VALLIMAR SUBDIVISION ADDITION, RESUBDIVISION OF AND ADDITION TO

APPLICATION NUMBER 35 DATE January 8, 2004

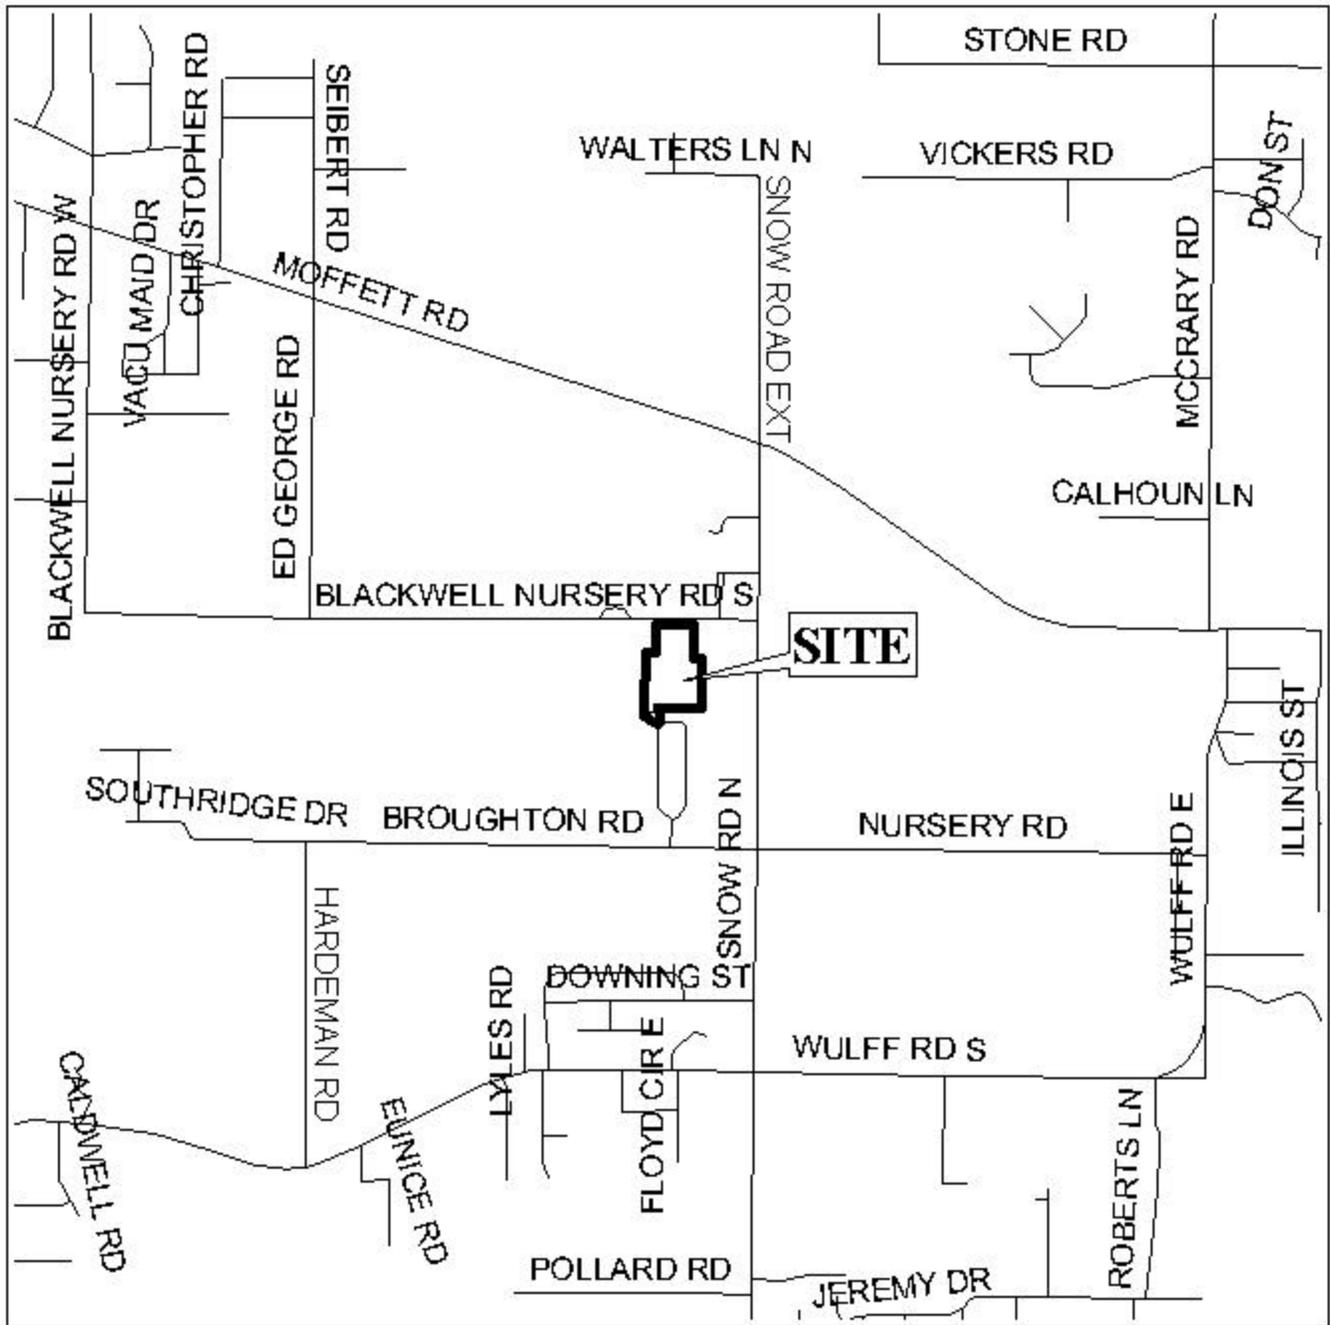
The current application includes additional property (Lot 2 fronting Blakewood Drive North) and reduces the overall number of lots from six lots to five. Additionally, the flag lots are now 50-foot wide (which would accommodate a street); the previous layout had lot widths ranging from 25-37.5 feet wide.

As outlined above, the current application provides better compliance with the Regulations than the existing subdivision. However, as Lot 2 has only 36-feet of frontage, the placement of a note on the final plat stating that there shall be no future subdivision of Lot 2, should be required. Additionally, a note should be placed on the final plat stating that Lots 1 and 3 are limited to one shared curb cut to Blackwell Nursery Road, should also be required.

As proposed, Lots 1 and 3 would exceed the width to depth ratio, therefore a waiver of Section V.D.3. would be required.

This site is located in the County, thus a note should be placed on the final plat stating that any lots which are developed commercially and adjoin residentially developed property must provide a buffer, in compliance with Section V.A.7. of the Subdivision Regulations.

With a waiver of Section V.D.3., the plat meets the minimum requirements of the Subdivision Regulations and is recommended for Tentative Approval subject to the following conditions: 1) the placement of a note on the final plat stating that Lots 1 and 3 are limited to one shared curb cut to Blackwell Nursery Road, with the size, location and design to be approved by County Engineering; 2) the placement of a note on the final plat stating that there will be no further resubdivision of Lot 2; and 3) the placement of a note on the final plat stating that any lots which are developed commercially and adjoin residentially developed property must provide a buffer, in compliance with Section V.A.7. of the Subdivision.
